Planning and Transportation Committee

Further Addendum for Agenda item 4.

Planning application 20/00869/FULEIA: 2-3 FINSBURY AVENUE LONDON EC2M 2PF

Image 1 – Example streamline indicating channelling of flow between the proposed 2-3 Finsbury towers directly at One Crown Place

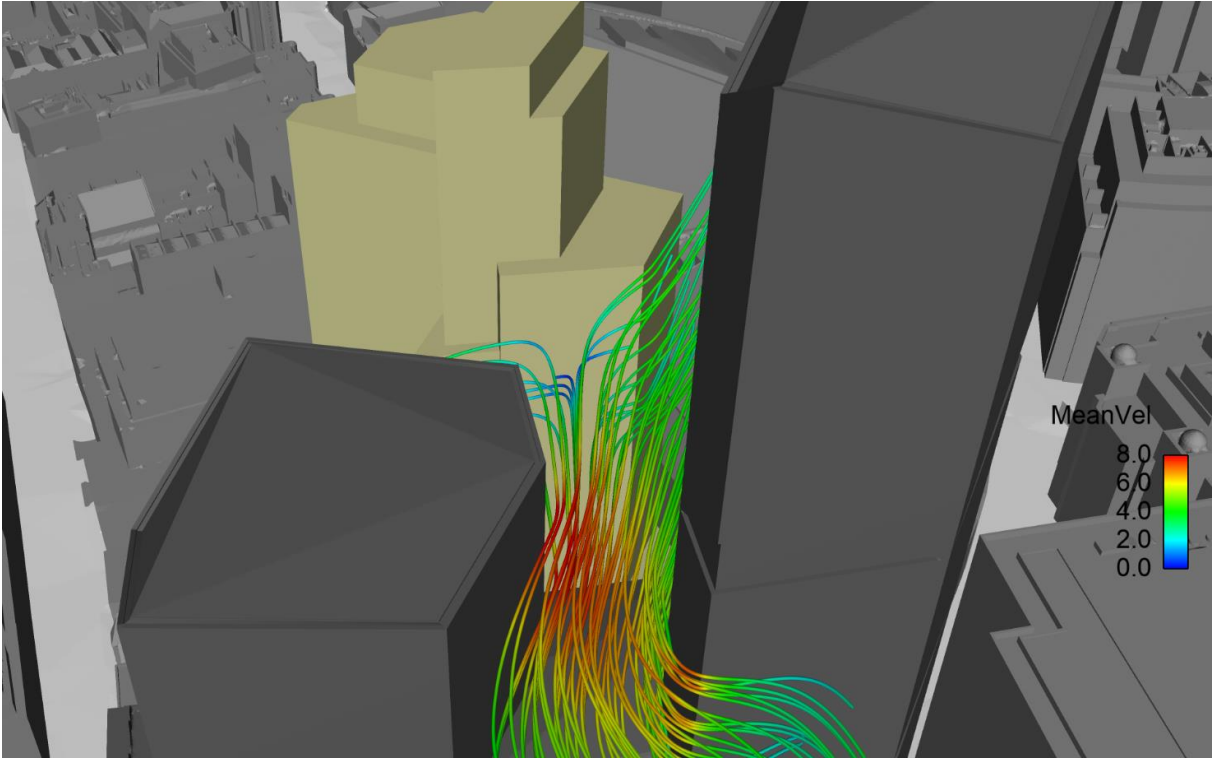
- The gap between the two towers channels air flow in a wind tunnel effect and directs the flow towards the façade of One Crown Place. This effect could cause comfort issues on the façade of One Crown Place. Image 1 in Appendix A highlights this.

- The flow visualisation presented in image 1 show the acceleration in wind speeds which is present between the 2-3FA towers, an unoccupied space. The review argues that this acceleration persists onto the OCP façade, which is not supported by the streamlines in Image 1 which change from red to green (a deceleration) as they approach OCP. No plots of wind speeds on OCP terraces have been provided by WR to support the claim that this flow behaviour results in an adverse impact on OCP.

Image 2 – Lawson Winter Comfort Plot for only the angles tested in our CFD assessment

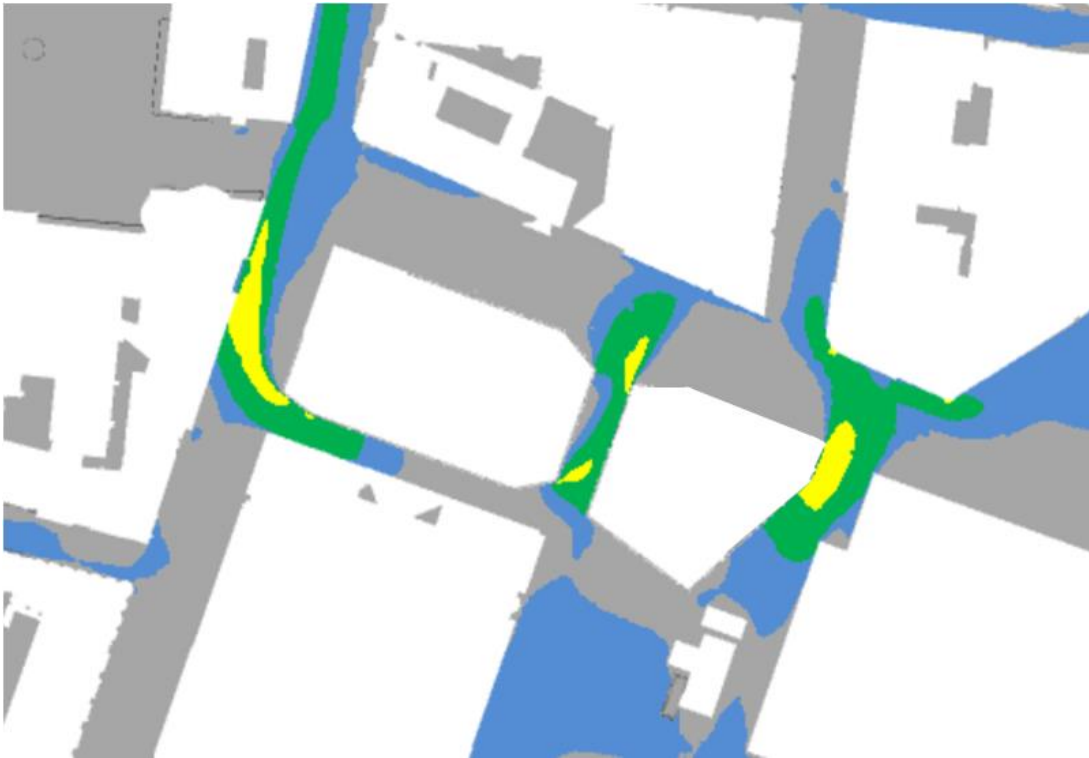
This assessment covers adverse impact on the One Crown Place development as well as potential adverse impacts on the wider surrounds. It was carried out using 8 wind angles spaced at 20° increments over the key south and south-westerly wind angles which reflect the most significant winds in the City of London, as well as the proposed developments relative position to One Crown Place. A fine mesh providing high levels of resolution and allowed us to identify complex flows around the development. An identical study was carried out with the existing 2-3 Finsbury to assess current conditions. Lawson plots were formed from the results of the 8 angles using the City of London Weibull Coefficients at both 10° and 20° increments. Probabilities outside the range of the angles tested were discarded from consideration. These are reasonable indicative representations of the results resulting from the wind angles tested, to inform of potential areas of concern. No mitigation measures were included in the tests.

- It is acknowledged within the WR report that modelling was not undertaken in accordance with the CoL Guidelines, no information has been provided within the report with respect to the extent of surrounding buildings included within the model and other key aspects with respect to the accuracy and detail of their simulations.
- The CFD modelling has been undertaken from only 8 wind directions which is a conservative approach and overweights the prevailing winds. These results have been combined with climate data to provide an assessment using the City of

London Lawson Criteria. To apply the Lawson Criteria to such a small number of wind angles is an incorrect interpretation of the Criteria and is not valid.

Image 3 – Lawson Winter Comfort Plot for angles tested, with expanded probabilities to fill the gaps between angles tested.

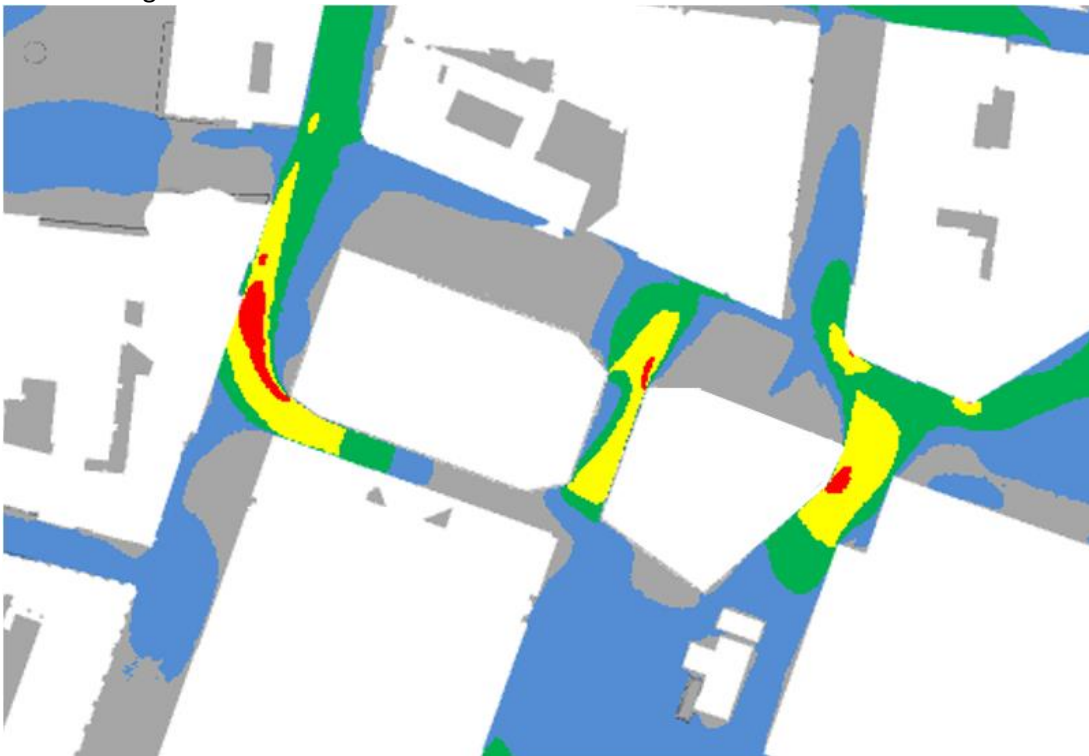
At 10° increments probabilities this region is close to the limit of walking/uncomfortable categories, and no mitigation measures are either proposed in this area or part of the future planning condition. This region is highlighted in images 2 and 3 of Appendix A. Image 2 represents the 10° increment probabilities and therefore gaps are present in the sector measured. Image 3 expands the probability to fill the gaps between the probabilities tested within the sector.

- Image 3 presents results with an interpolation between the assessed angles to consider all wind directions. Given the impact that a small change in wind direction can have on local wind conditions, and the small number of angles tested, interpolation between wind angles is not a valid methodology. The results presented show a one category increase in comfort conditions across most spaces once the interpolation is applied which is unrealistic, further raising concerns with the interpolation approach used.

Image 4 – Streamlines highlighting origins of flow through the central passage responsible for elevated comfort levels at 220°, a critical angle highlighted in Lawson Plots

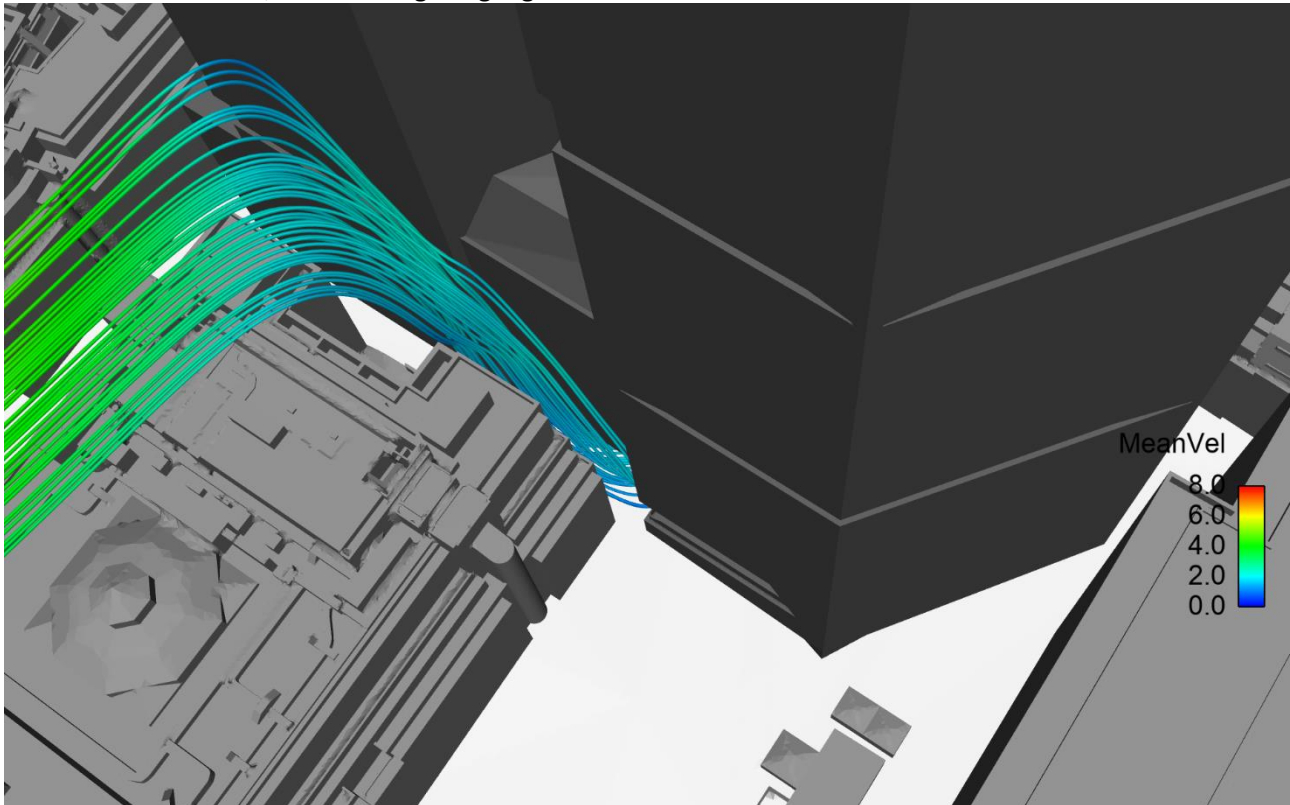
Whilst it is recognised that using a Lawson assessment does not reflect the City of London microclimate more stringent guidelines, our assessment indicates a potential region of comfort exceedance at the Sun St end of the central passage underneath the podium of 2-3 Finsbury when expanding the probabilities to reflect the 20° increments. The reverse streamlines from the region of interest indicate the mitigation measures introduced in the applicants CFD and Wind Tunnel reports (in particular the planting in Finsbury Avenue Square and Whitecross Place porous umbrellas) are not in regions through which the stream would pass. This stream is shown in Image 4. This region is of potential concern and should be considered within the post completion wind audit and mitigation introduced if conditions are found to be unsuitable, should this not be considered an area to require further study before commencement of construction.

- Flow visualisation presented in image 4 shows flow hitting the west tower, travelling down the façade and through the passageway. The review argues that this behaviour negates the benefit of the proposed wind mitigation umbrellas within Whitecross Place. However, the flow visualisation presented by WR only shows flow down a part of the façade, and if the streamline was moved to the west it would likely show an interaction with the proposed umbrellas as per the image below (from Ramboll CFD, wind direction 240°).
